RFI and DRP response DA-2020/391, 588-592 Princes Highway, Rockdale

Please find below a response prepared with the assistance of Mako Architecture to the Design Review Panel minutes issued 27 April 2022, your RFI of 14 March 2022 and the Development Engineer's request forwarded 28 April 2022 .

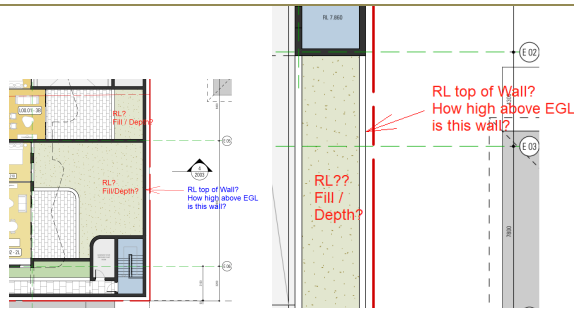
3D of ADG requires 25% site area = 519.25sq/m – 480sq/m proposed at roof, deficiency of 38.75sq/m. Terraced planter adjoining southern tail of building not included in calculations, calculations identified in red below.

Nil detail provided with regards to shade structures within Level 11 communal area. Relevant detail requested. i.e. height, materials, RL etc.

The communal open space has been refined in response to Council and Panel comments but it is not agreed that there is a deficiency or that an internal common room is warranted or reasonable given the amount of communal space provided.

Refer to plans 1724 - DA2 2001 and 1724 - DA2 1005 for details of the shade structure, which has a height of 3.1m and materials comprising of steel and woven metal tensile infill.
